Mackay Dam: Failure Far More Likely Than Previously Thought

Environmental Defense Institute

September 2, 2022

Mackay Dam, Custer County Idaho

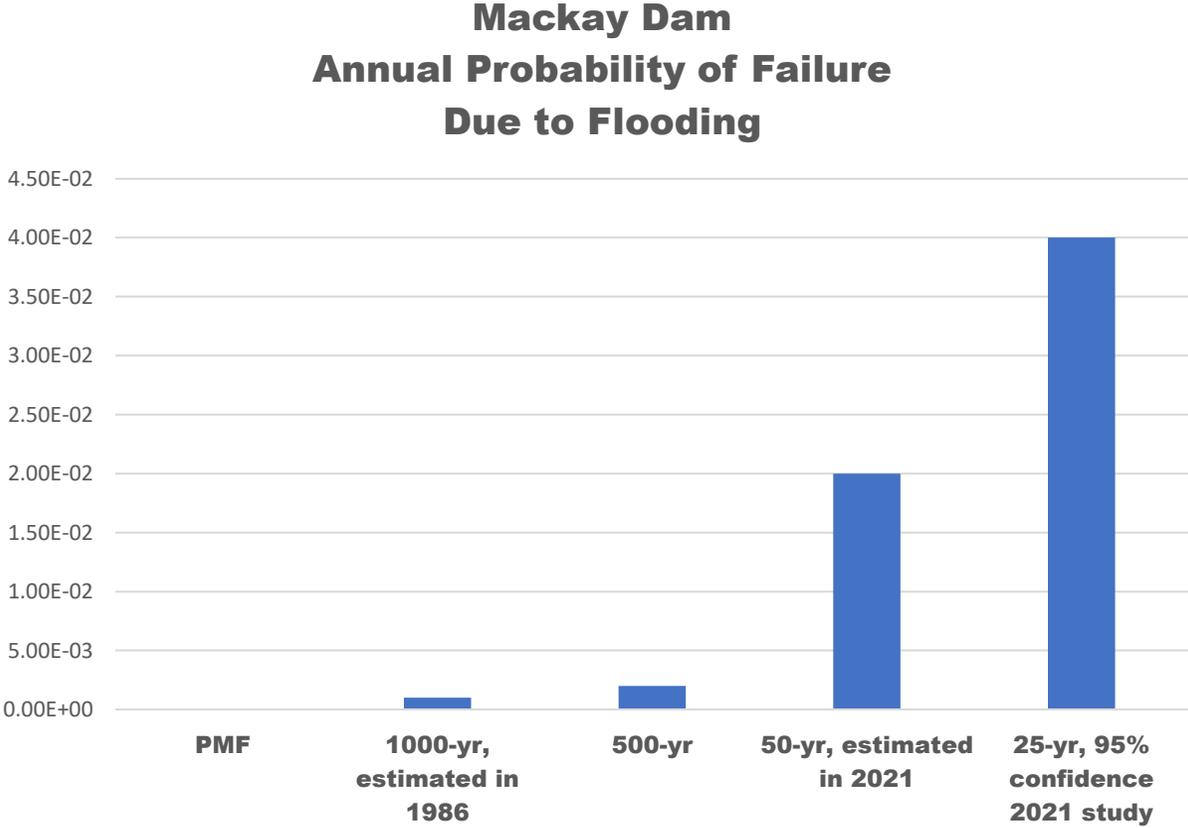
The concrete core wall is of partial height and inadequate design and construction. The sandy gravel fill was not compacted.
